Service-Information Motorcycle

Group: 16
Fuel Tank
And Lines

July 1987
16 015 87
(2244)

Fuel Cap Dust Lip Chafing Fuel Tank Surface - Boxer Models

Fig. 1

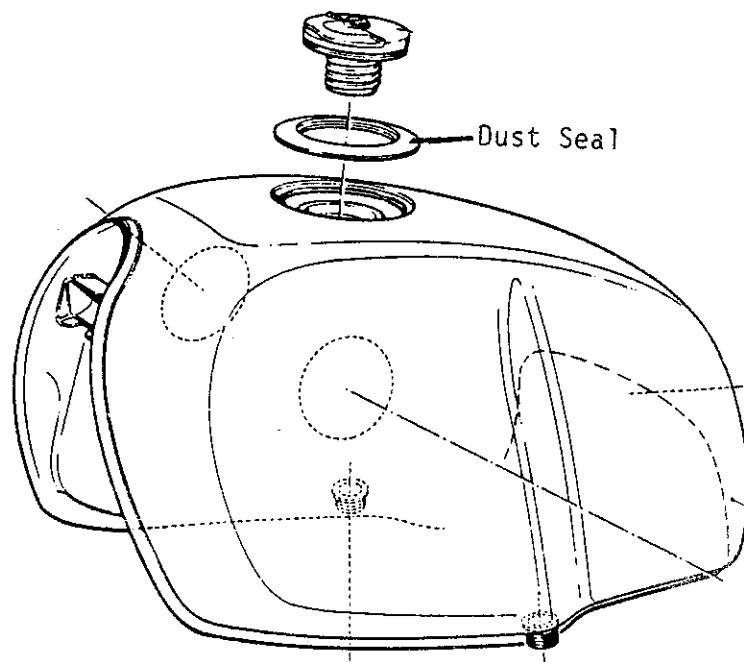
Information: To prevent fuel tank's painted surface from being rubbed or chafed by the Dust Seal (Fig. 1), an O-Ring 44 x 4 mm (Part No. 11 42 1 337 098) can be fitted between the sealing surfaces as shown in Fig. 2.

The O-Ring will restrict compression of the fuel cap seal, raising the overall cap height when tightened, thereby preventing the Dust Seal from rubbing against the painted surface.
